NESPA
TILED SPAS

Production Booklet

FRENCH SPA

DRAWING REVISION HISTORY

DWG TYPE
SD-5

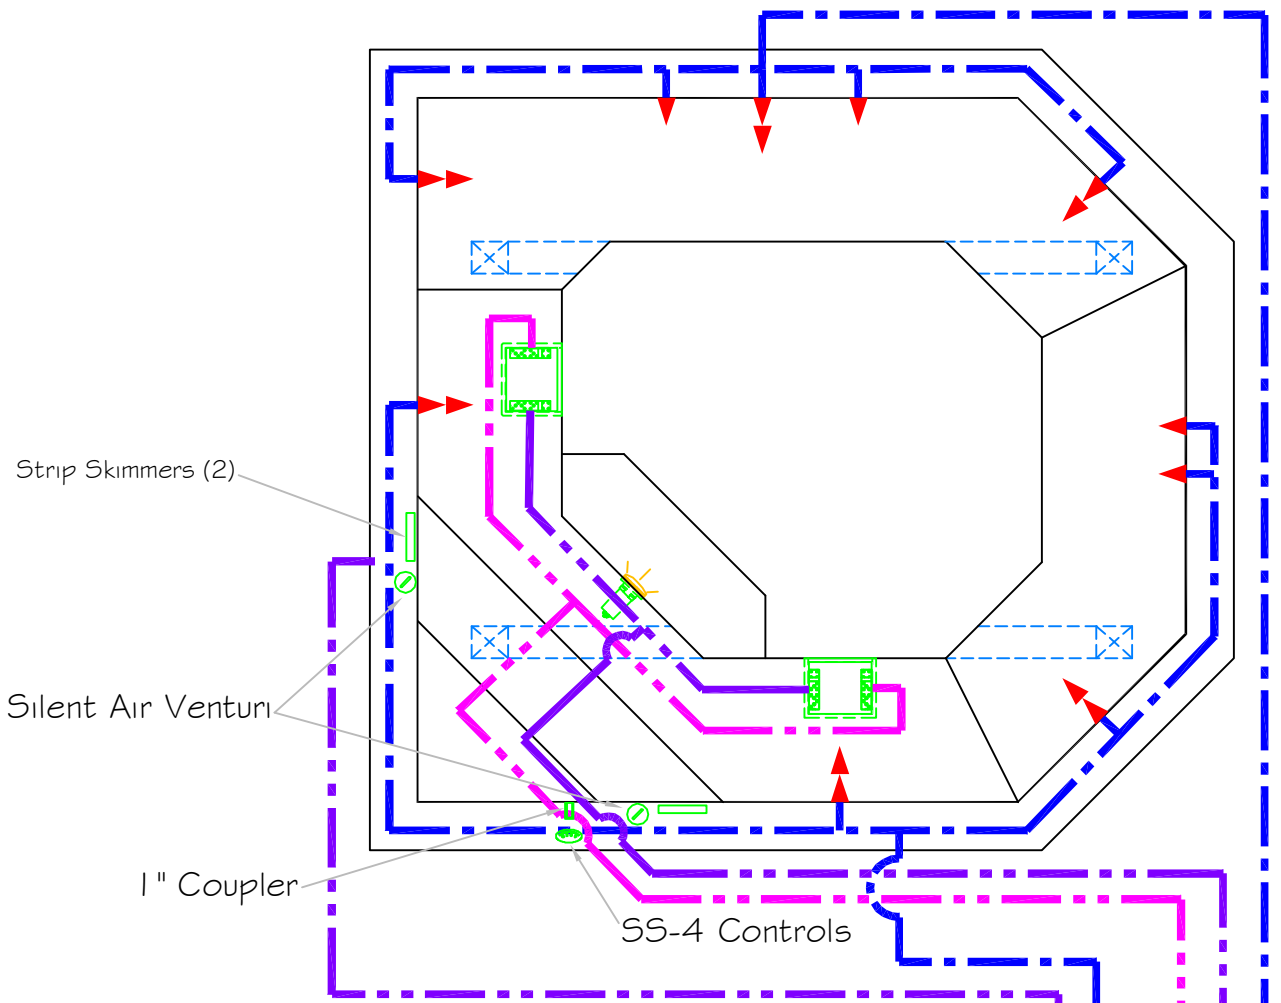
REV NOTE: 7-20-07 - Changes spa shape to 45deg corners

REV NOTE: 8-5-07 - Moved Light, Changed lip to 8"X 2"

REV NOTE: 8-9-07 - Changed lip to 6"X 2"

REV NOTE: 8-17-07 - Changed Skimmer to Strip Type

REV NOTE: 8-28-07 - Changed jet configuration and air venturi location
